**TOWN OF MOUNTAIN VILLAGE
REGULAR DESIGN REVIEW BOARD MEETING AGENDA
THURSDAY JUNE 6, 2024, 10:00 AM
MOUNTAIN VILLAGE TOWN HALL
455 MOUNTAIN VILLAGE BLVD, MOUNTAIN VILLAGE, COLORADO
TO BE HELD HYBRID THROUGH ZOOM:**

3.	10:02	15	Perez/ Applicant	Quasi-Judicial	Review and Recommendation to Town Council regarding a height variance for Lot 165 Unit 2, TBD Cortina Dr, pursuant to CDC Section 17.4.16.

4.	10:17	30	Perez/ Applicant	Quasi-Judicial	Consideration of a Design Review: Initial Architecture and Site Review for Lot 165 Unit 2, TBD Cortina Dr, pursuant to CDC Section 17.4.11.

5.	10:47	30	Nelson/ Applicant	Quasi-Judicial	Consideration of a Design Review: Final Architecture Review for Lot 926R, TBD Sundance Lane, pursuant to CDC Section 17.4.11. <i>This item was continued from the March 7, 2024, Design Review Board Meeting.</i>

ROOF PLAN MAX HEIGHT **3**

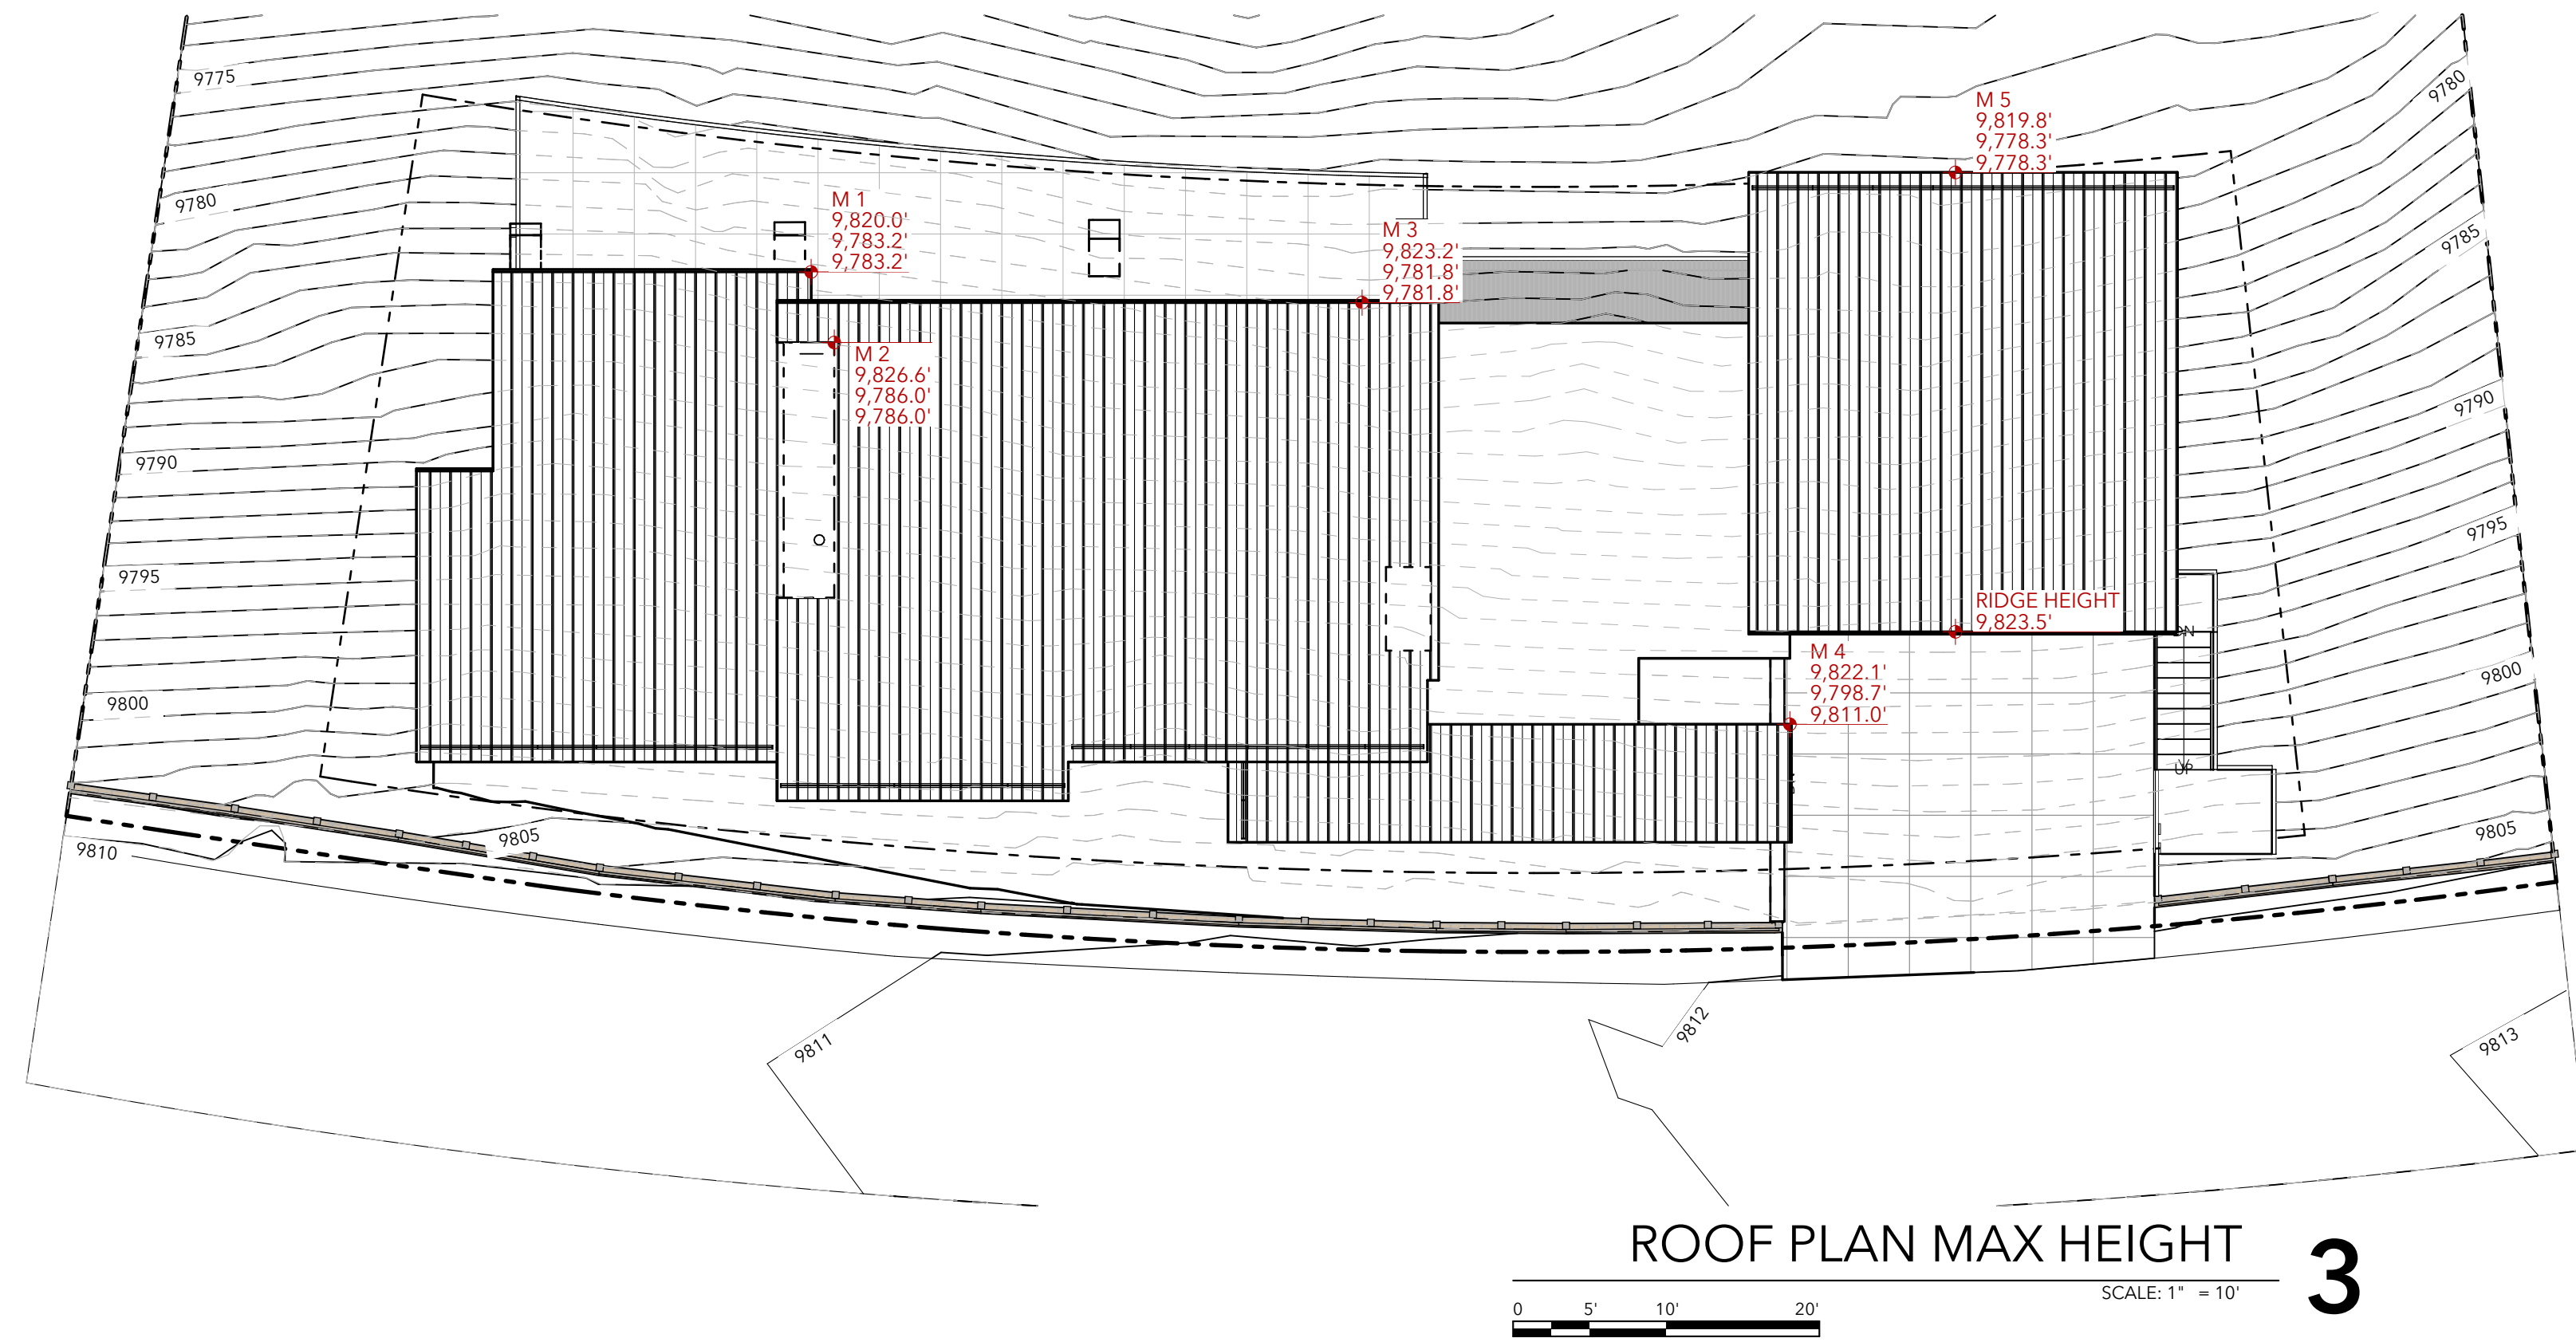
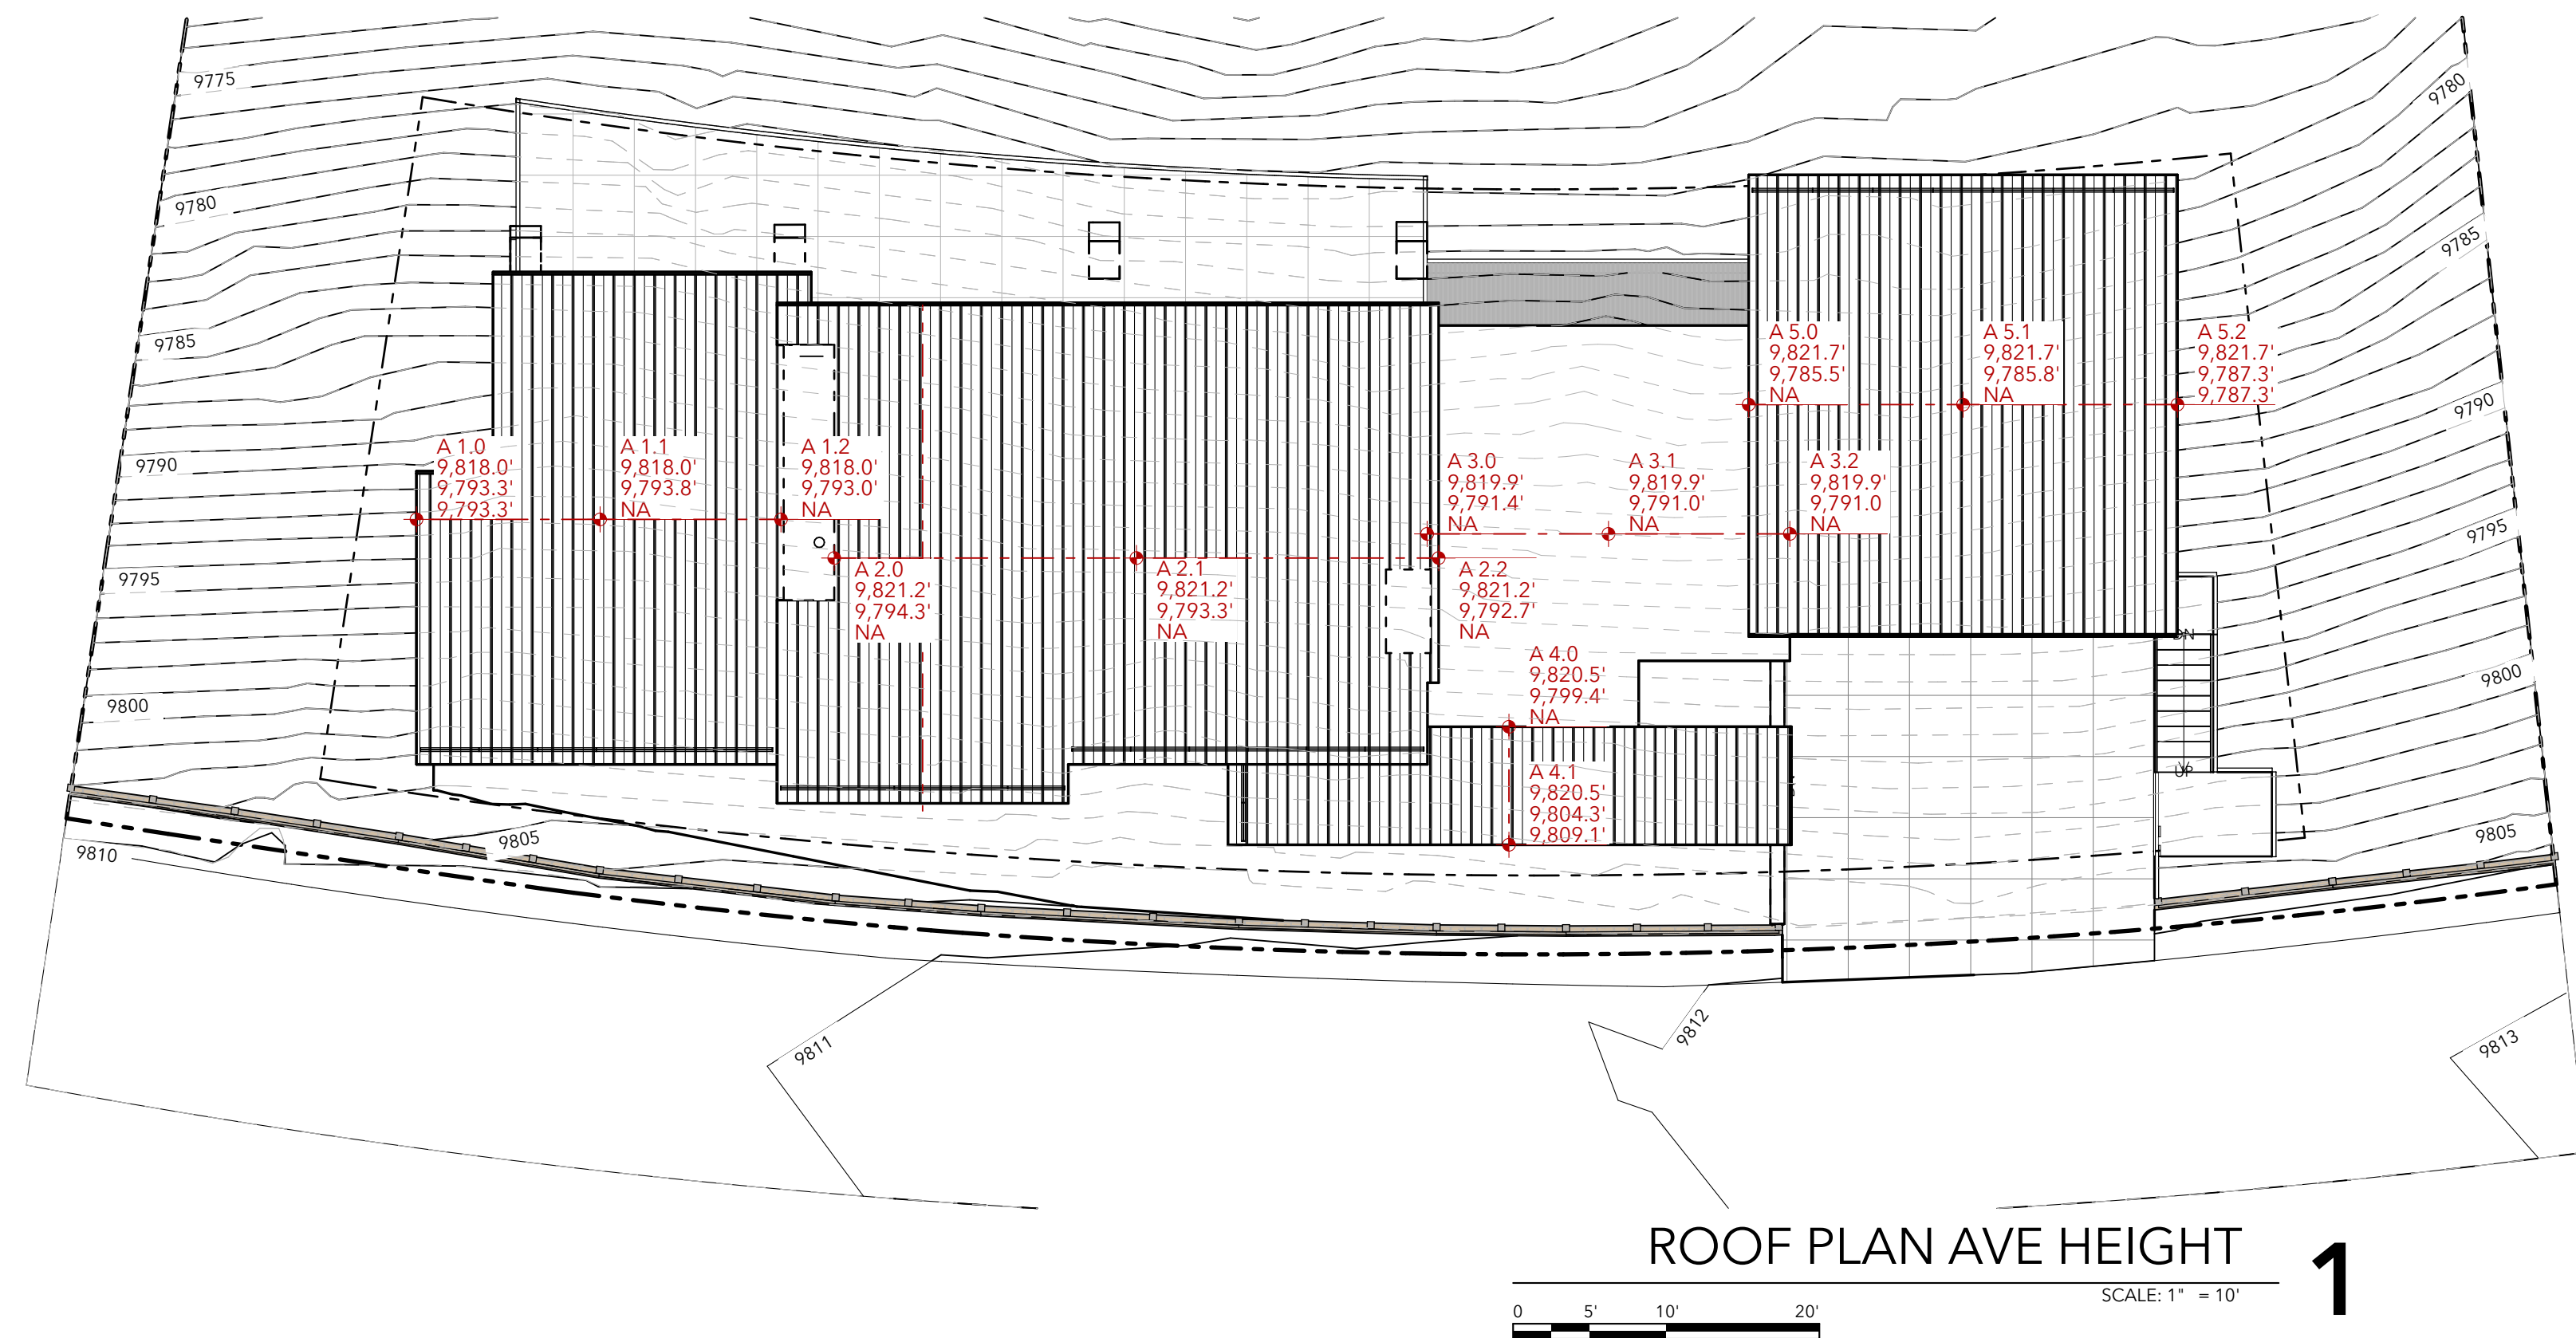
Sections 17.3.11 and 17.3.12 of the CDC provide the methods for measuring maximum building height and average building height, along with providing the height allowances for specific types of buildings based on their roof form. The proposed design incorporates gable roof forms. Single-family, condominium developments are granted a maximum height of 35 feet and an average height of 30 feet. The average height is an average of measurements from a point halfway between the roof ridge and eave. The maximum height is measured from the highest point on a roof directly down to the existing grade or finished grade, whichever is more restrictive.

- 4) *A monumented land survey shall be prepared by a Colorado public land surveyor to establish the maximum and average building height.*
- 5) *The applicant shall work with public works and utility providers to finalize the utilities plan as a condition of approval prior to building permit.*

L1.0

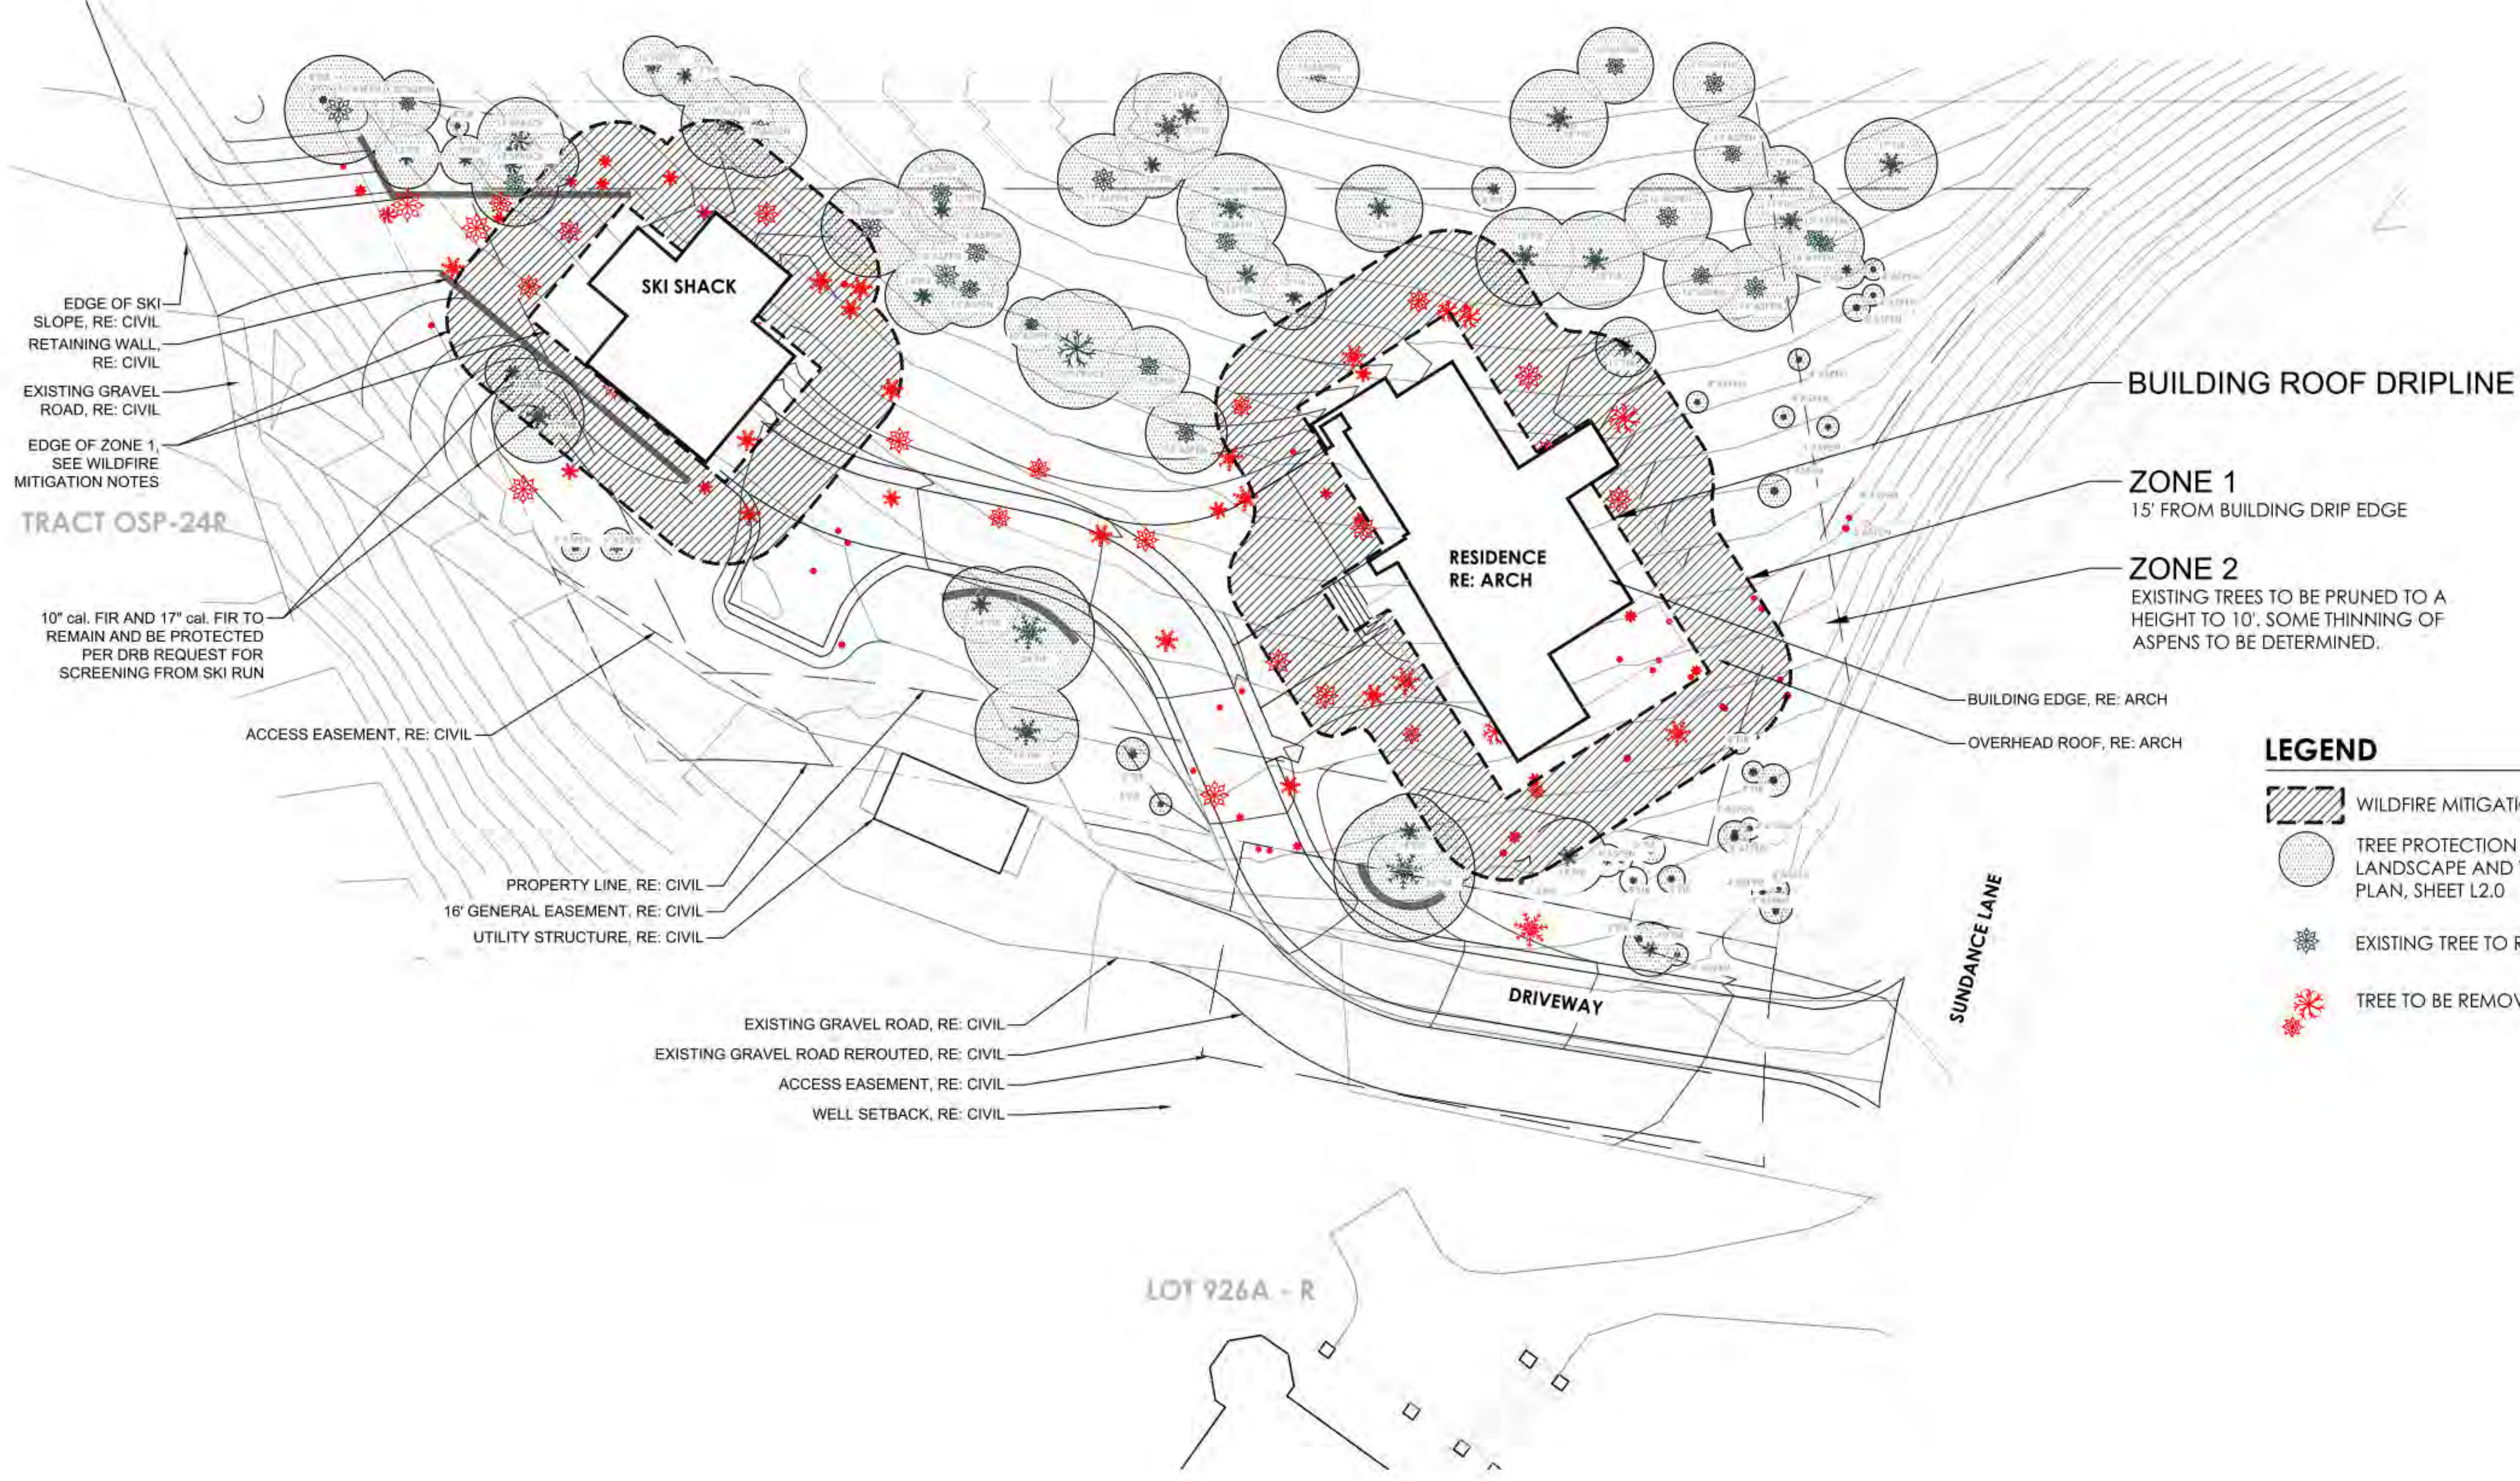
The application includes Fire Mitigation Plan on Sheet L1.0. The applicant has revised the plan to remove more trees than indicated on Sheet A1.0 to meet the CDC requirements at building permit. The revised plan also indicates that 2 trees (10" and 17" caliper firs) would remain and be protected within Zone 1 adjacent to the ski shack to provide screening from the ski run.
